POLE ASSEMBLY

GEM-TEC CORPORATION	
TYPE "U" POLE	
65 FT. W/ MOD. BASE	
	SHEET _ OF _
UPOLE65B.DWG	12/4/98

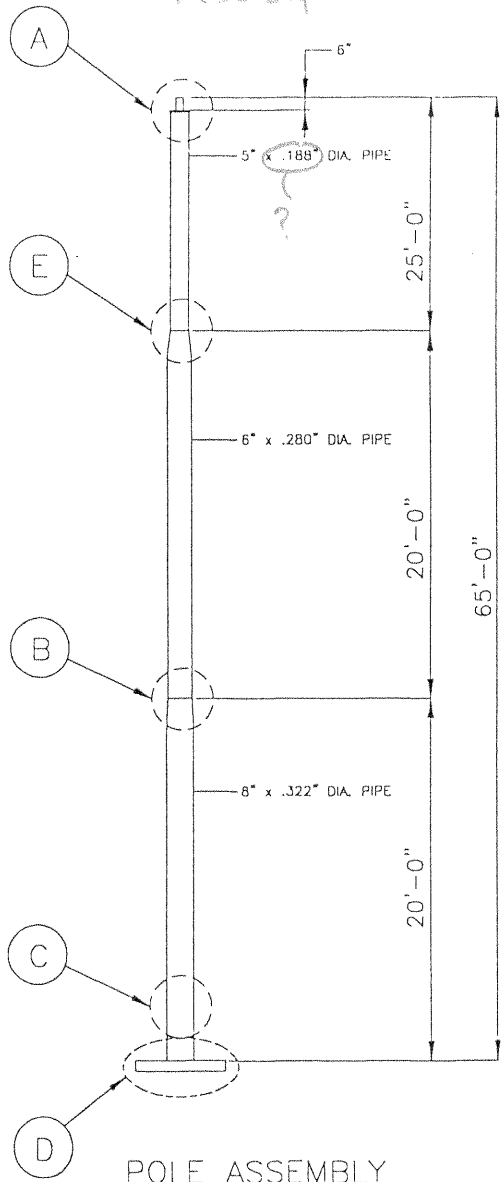
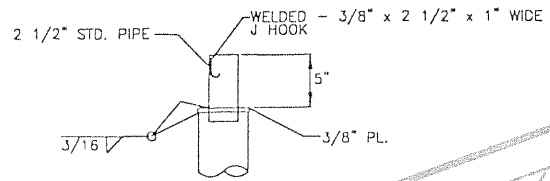
- Secondary bonding?
 - is 10' 5" x 0.188" Dia. Pipe standard?
 - 55 ksi bolts will be acceptable with the rectangular bolt pattern, See 1, 3 & 4 where
 FK-0.5G

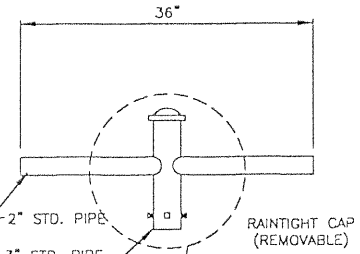
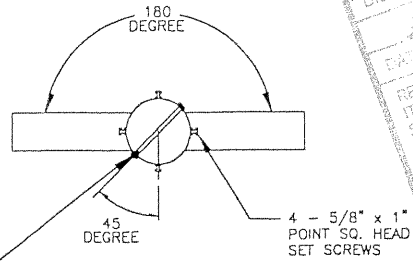
- specify 1/2" weight + area, specify velocity wind load + other specs
